FOXCONN		HON HAI Precision Ind. Co., Ltd. CCPBG - R&D Division	
Title DB CONN (Fingerprint)			
Size A	Document Number V030 MP		Rev 1.1
Date:	Thursday, January 20, 2011	Sheet 1 of 19

FOXCONN		HON HAI Precision Ind. Co., Ltd. CCPBG - R&D Division	
Title LID L			
Size A	Document Number V030 MP		Rev 1.1
Date:	Thursday, January 20, 2011	Sheet 7 of 19

FOXCONN		HON HAI Precision Ind. Co., Ltd. CCPBG - R&D Division	
Title History Touchpad			
Size A3	Document Number V030 MP		Rev 1.1
Date:	Thursday, January 20, 2011	Sheet 18 of	19

Fingerprint BTB CONN.

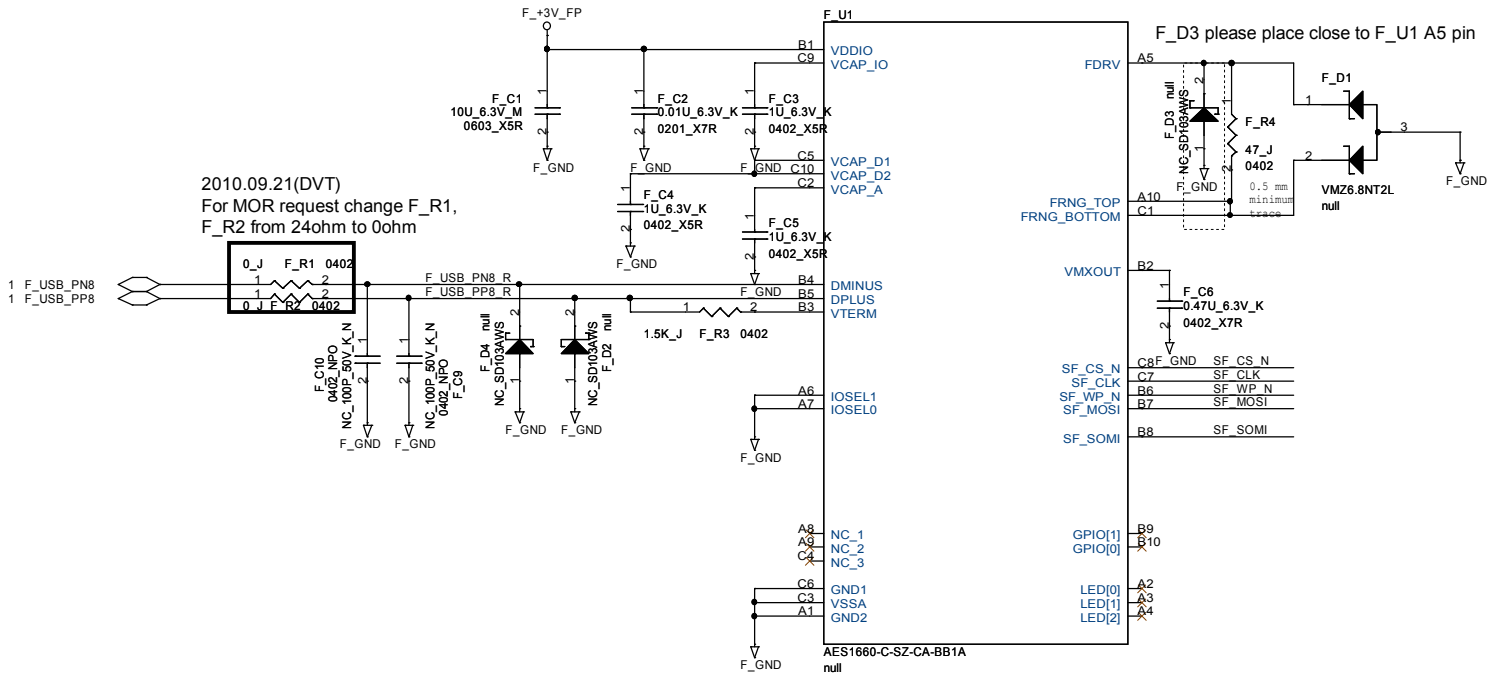
2010.09.20(DVT)
For F_U1 15-AES1660-0000
used for lenovol change to
15-AES1660-0001

2010.12.27
For MOR request F_U1
change from 15-AES1660-0001
to 15-AES1660-0002

2010.09.21(DVT)
For MOR request change F_R1,
F_R2 from 24ohm to 0ohm

Power/Suspend LED

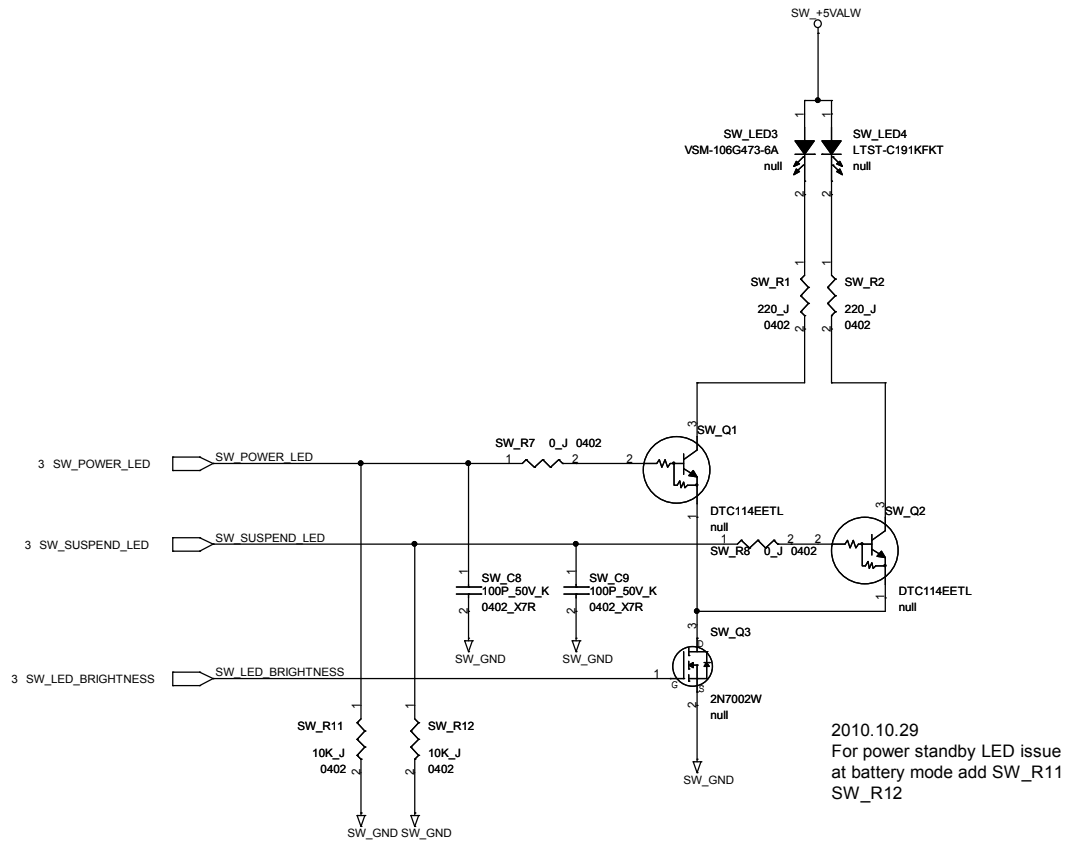
Change SW_R11 and SW_R12 from 1R-0000104-J200 to 1R-0000103-J200
 Change SW_R5 and SW_R6 from 1R-0000151-J200 to 1R-0000101-J200
 Change SW_R1 and SW_R2 from R-0000151-J200 to 1R-0000221-J200
 Modify LED brightness 01/20

2010.10.29
For power standby LED issue
at battery mode add SW_R11
SW_R12

ODD/HDD LED

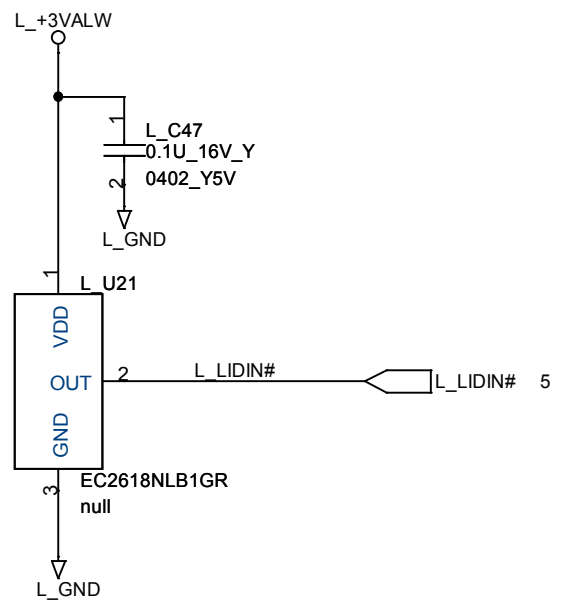
2010.10.30
For EMI test fail L_VR1
 L_VR2, L_VR7 change from
NC to mount, L_Q1 change
from 17-ME2N700-2E00 to
17-2N7002E-SP00

Change L_R23 and L_R24 from 1R-0000151-J200 to 1R-0000331-J200
Adjust LED brightness 01/20

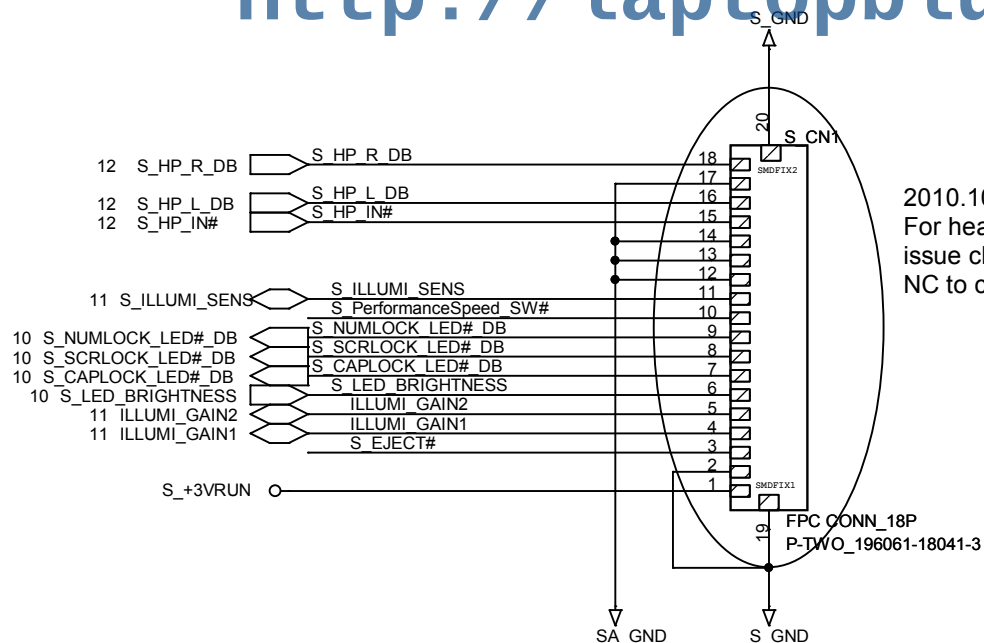
2010.1014
For headphon crosstalk
issue change pin12,13,14
NC to connect to A_GND

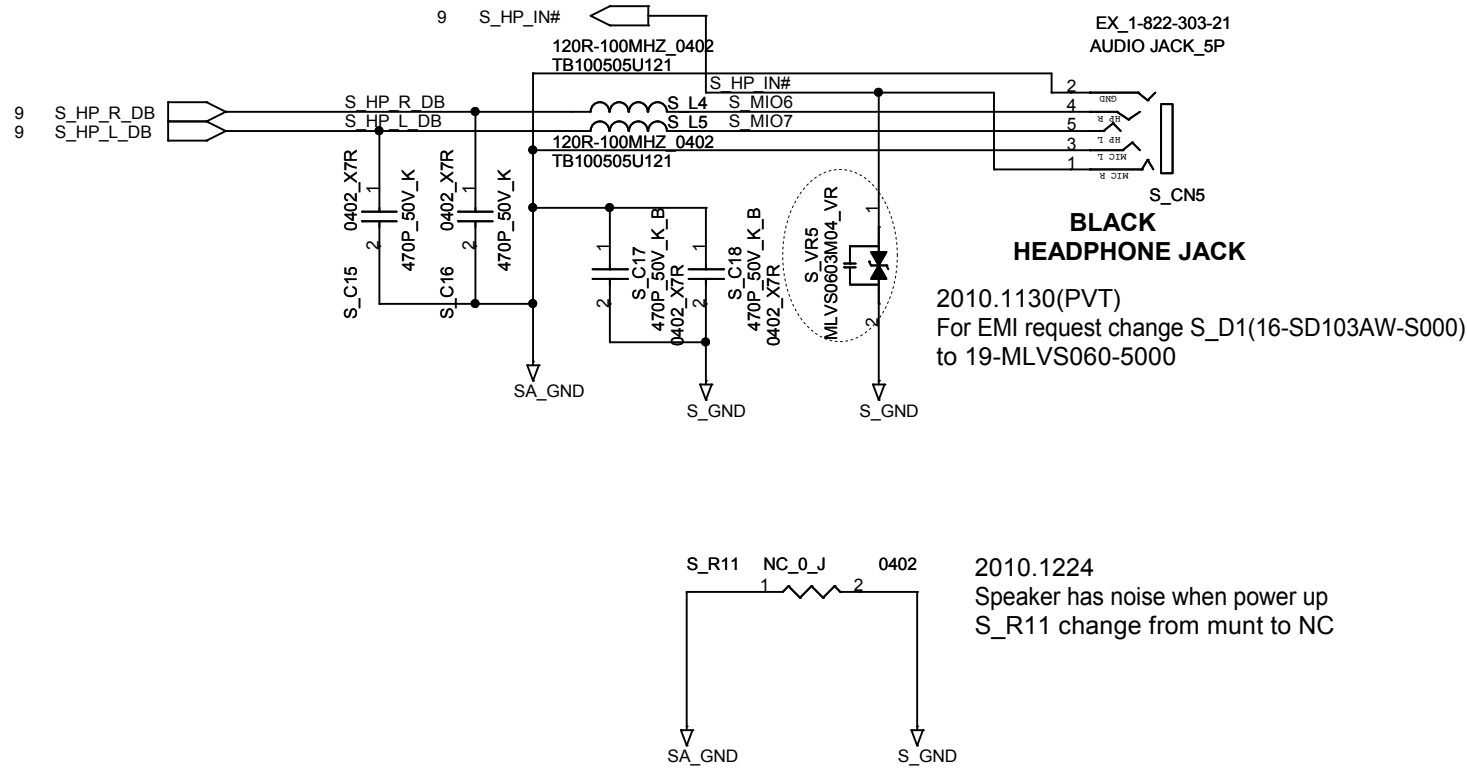
2010.09.20(DVT)
Light sensor follow V050 change from 15-BH1600F-0000 to 15-BH1621F-0000
